# FINAL CR Kendall Mine Closure Environmental Impact Statement

**FINAL**  
**CR Kendall Mine Closure**  
**Environmental Impact Statement**

5.1.4	Process Pad Barrier Cover Alternative .....	5-2
5.2	Preferred Alternative.....	5-3
5.2.1	Rationale for the Preferred Alternative .....	5-3
<b>Chapter 6</b>	<b>List of Preparers .....</b>	<b>6-1</b>
<b>Chapter 7</b>	<b>Glossary and Acronym List .....</b>	<b>7-1</b>
<b>Chapter 8</b>	<b>References.....</b>	<b>8-1</b>
<b>Chapter 9</b>	<b>Response to Comments.....</b>	<b>9-1</b>

Completed areas within the Kendall Pit.

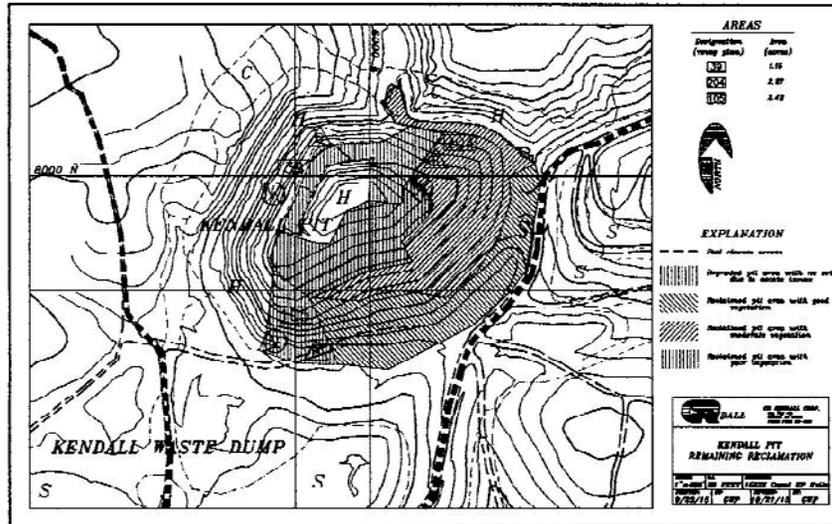
highwall, falling debris was a safety concern and will likely cover any soil placed there. Area 105 totals 2.42 acres comprising slopes of less than 2:1 which cannot be reduced due to composition of the highwall. Area 204 totals 2.09 acres and cannot be completed because any further slope reduction will compromise the Mason Canyon drainage. Unlike the Muleshoe pit, The Kendall pit was not re-graded prior to publishing the Soils and Revetigation Plan and as such, Schafer could not accurately determine the total of what could be completed.

Soil placed in the Kendall pit was generally considered the poorest remaining on site. Those soils originated from stockpiles TS-4 and TS-21. TS-4 originated, in part, from stockpile TS-13a, the same source as proposed to be used in any future soil placement. This soil was separated from TS-13a during the grading of the upper Kendall waste dump runoff bench after it was determined that drainage ran through TS-13a. If this resource is not performing as it should in the pit now, will placing more above be of any beneficial use?

Section 2.4.1 (Process Pad Drainage Pretreatment Alternative) has been revised to eliminate the additional soil placement in the Kendall and Muleshoe pits.

Sections 2.4.1 and 2.4.2 have been revised to require that CR Kendall modify the seed mix based on the 2008 recommendations and reseed the lower slopes of the pits. DEQ will stipulate that CR Kendall propose amending the lower slopes of the Kendall and Muleshoe pits after seeding with an agency-approved organic amendment if equipment can safely be mobilized into the pit bottoms. DEQ will not require planting ponderosa pine as it volunteers regularly on the mine site without seeding or planting.

**FIGURE A-4**  
CR Kendall Mine  
Arsenic, Selenium, and Thallium Levels in  
Mason Canyon Groundwater  
(TMW-24A)

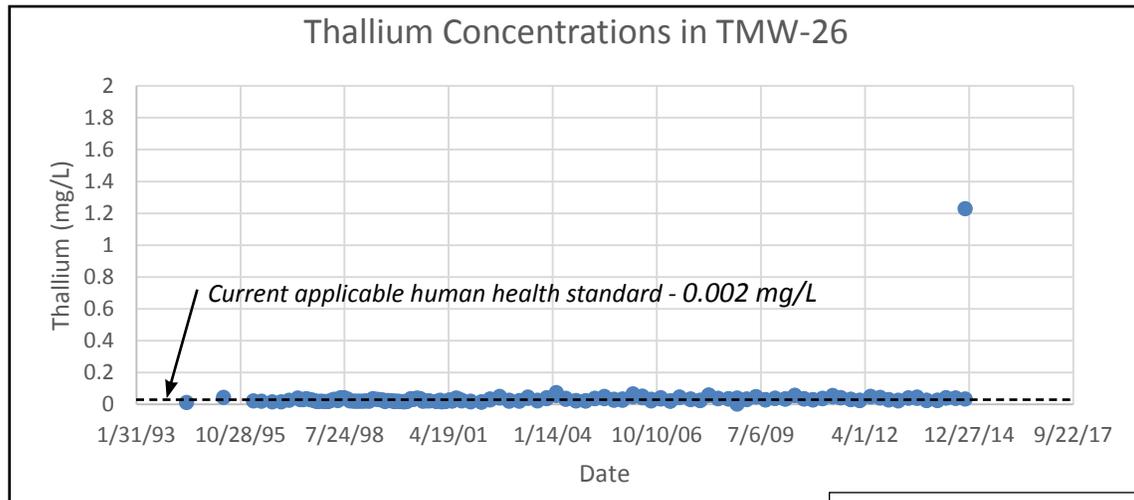
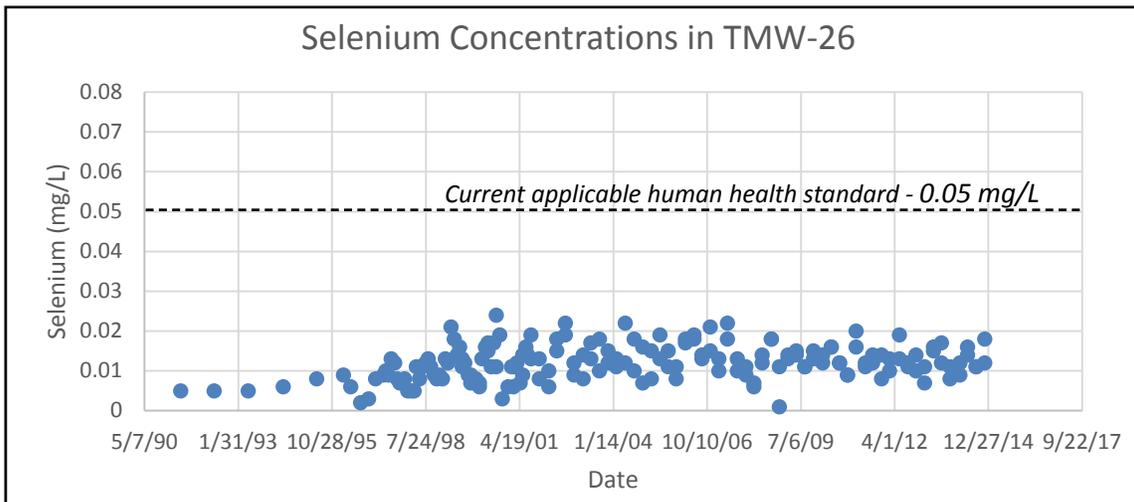
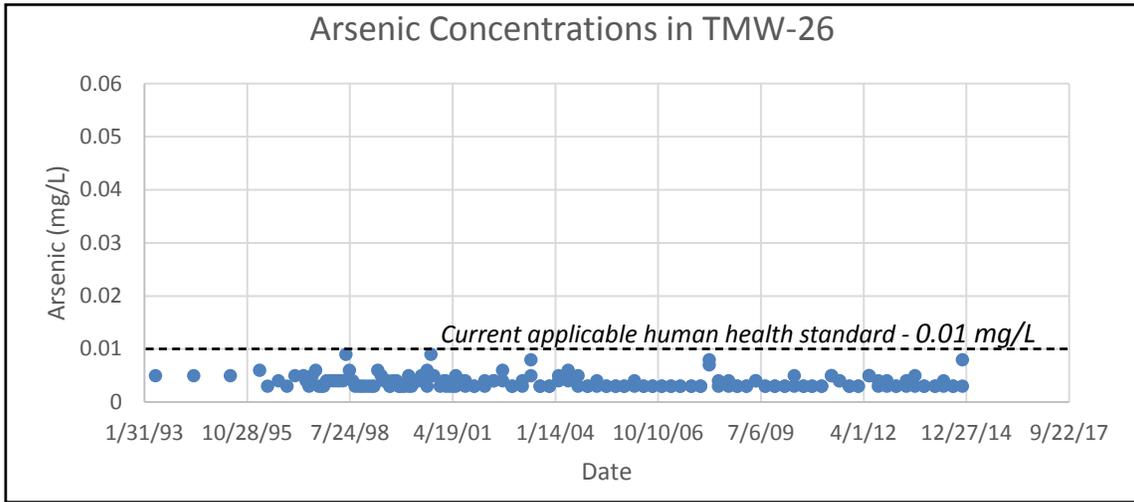
The monitoring wells demonstrate that water continues to exceed standards in surface water and groundwater monitoring wells, including Mason Canyon groundwater at TMW-24A (Figure A-4); and Mason Canyon surface water KVSW – 4 (Table 3-10, P. 3-20), surface water in Barnes King Gulch (KVSW-3) (Table 3-12, p 3-22), groundwater in Barnes King Gulch (TMW-30A)(Table 3-22, p. 3-30), and the Section 29 spring (Table 3-15, p. 3-25).

The monitoring wells demonstrate that contaminated water continues past the pumpback system in some cases, including Mason Canyon groundwater at TMW-24A (Figure A-4); and Mason Canyon surface water KVSW – 4 (Table 3-10, P. 3-20), surface water in Barnes King Gulch (KVSW-3) (Table 3-12) and groundwater in Barnes King Gulch (TMW-30A)(Table 3-22) (p. 3-30).

Well TMW-24A (Figure A-4) in lower Mason Canyon has shown elevated arsenic concentrations since the late 1990s, with a trend of improving quality over the past 8 years. This arsenic does not appear to be derived from the CR Kendall mine site, as all shallow groundwater within the Process Valley drains through the underdrain into collection sump TMW-26, and this water has consistently remained within water quality standards for arsenic. During construction of the leach pads, historic tailings were removed from the process valley; however, deposits of tailings remain present downgradient of the CR Kendall mine site, and the arsenic detected in TMW-24A is suspected to be related to the presence of these tailings. Similar arsenic concentrations have been observed over many years in lower Barnes-King Gulch, where surface water flows through historic tailings.

**FIGURE A-8**  
CR Kendall Mine  
Arsenic, Selenium, and Thallium Levels in  
South Fork Little Dog Creek Groundwater  
(TMW-40D)

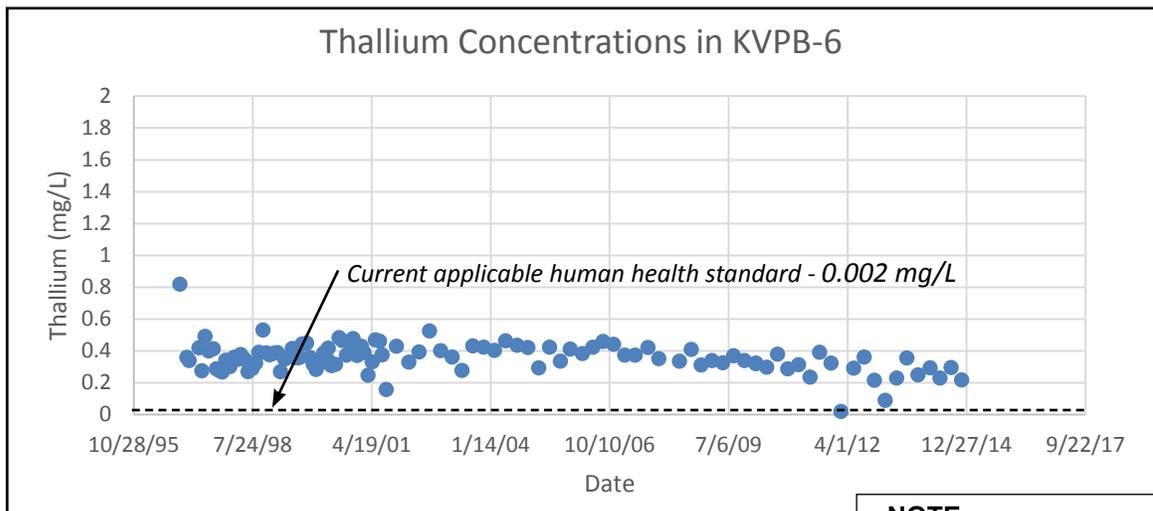
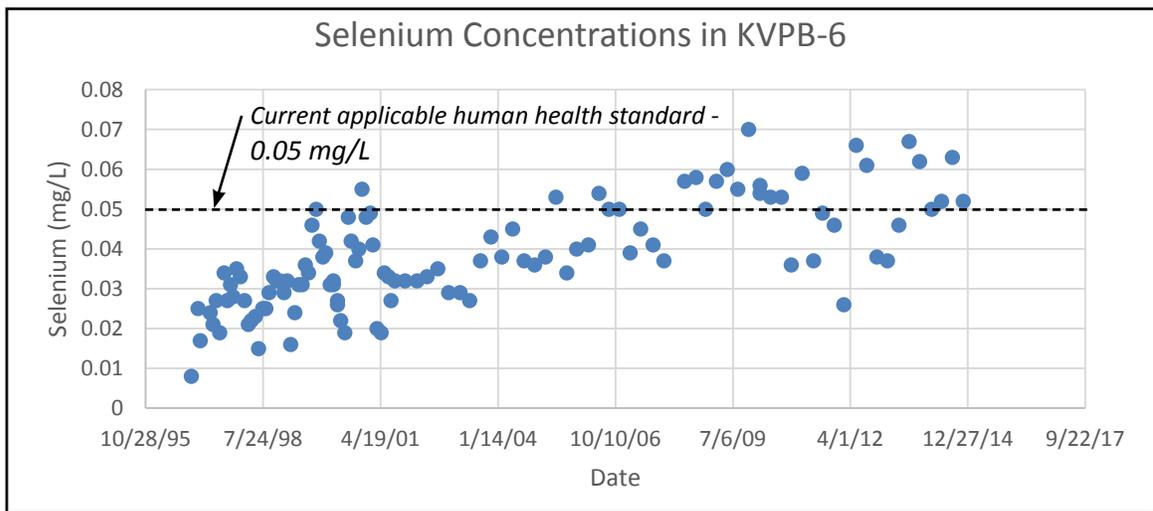
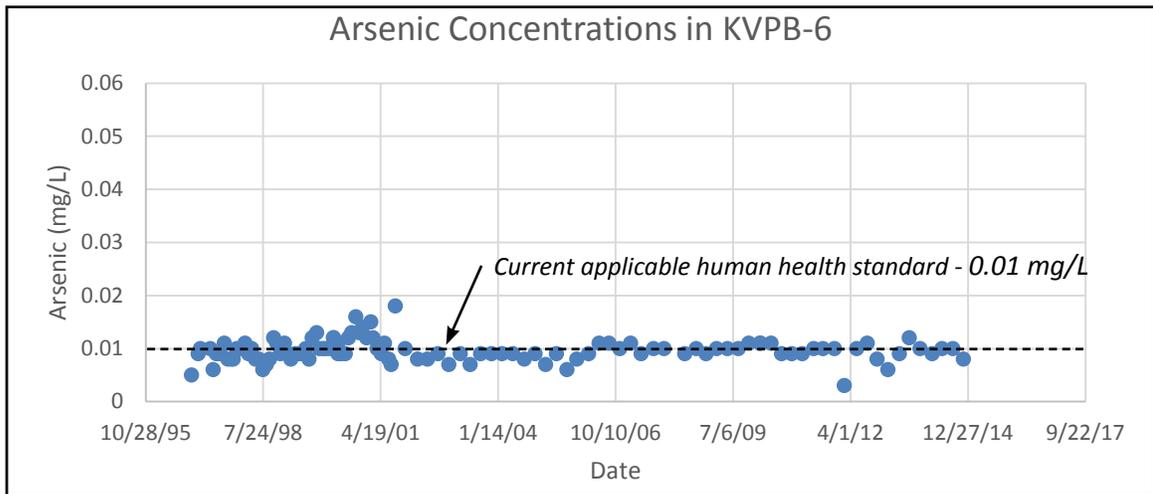
especially A-7, A-8, and A-9 indicate that the pollution levels are as bad as in 1995 or with the Selenium actually significantly worse. We have observed that if it is drier the contaminate levels are higher due to more concentration. We assume this is why you are allowing CR Kendall to take Spring Water which was designated by Water Rights for augmentation to the Little Dog Drainage and divert a part of it to the KVPB-6 as indicated on the Figure 2-2 piping chart. We are assuming the meter for water being sent down the pipe is at the Little Dog Creek Spring so water being diverted into the pumpback is being shown as being returned to the drainage. I can imagine no reason to divert clean spring water into the system other than to try to dilute contaminated water. We believe part of the problem with the KVPB 6 is the use of the LAD system, which has continually for over 20 years deposited more contaminates on the dump thus creating a vicious cycle. These pollutants will probably only continue to get worse as the LAD is allowed to continue for the next 100 years. Wayne Jepson told us in March that this was an emergency LAD but if that is so what was the emergency last week.

Figure A-8 presents water chemistry from monitoring well TMW-40D in Little Dog Creek downgradient of pumpback system KVPB-6. Arsenic concentrations at this location have remained below the detection limit throughout the period of record. Selenium concentrations have declined somewhat and have consistently remained below the human health standard. Data from the well show a few exceedances of the human health standard for
